## Technical change to 1812870000 + 1812890000

the products of 1812870000 (SAISWI-P-4A-4/5.1-M12) + 1812890000 (SAIBWI-P-4A-4/5.1-M12) will be changed after a transitional period.

1812870000 Old:

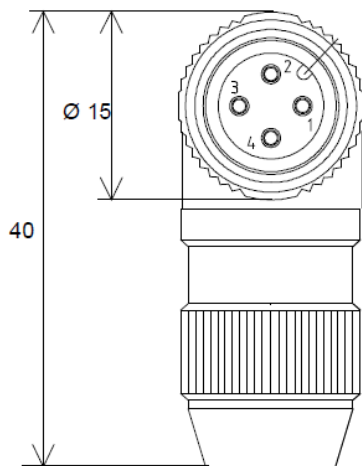
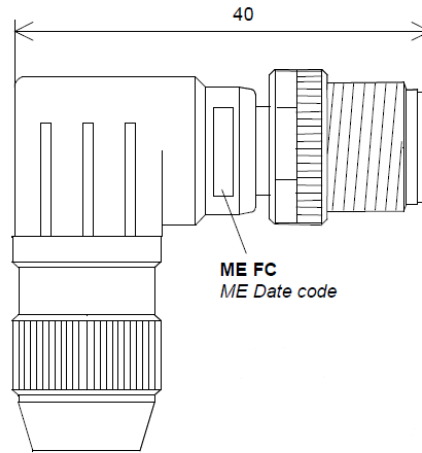
- Redesign: Optimization of product haptics and enlargement of the available labeling area
- UL certification
- Extension of product labeling by adding CE and UL certifications as well as the article number
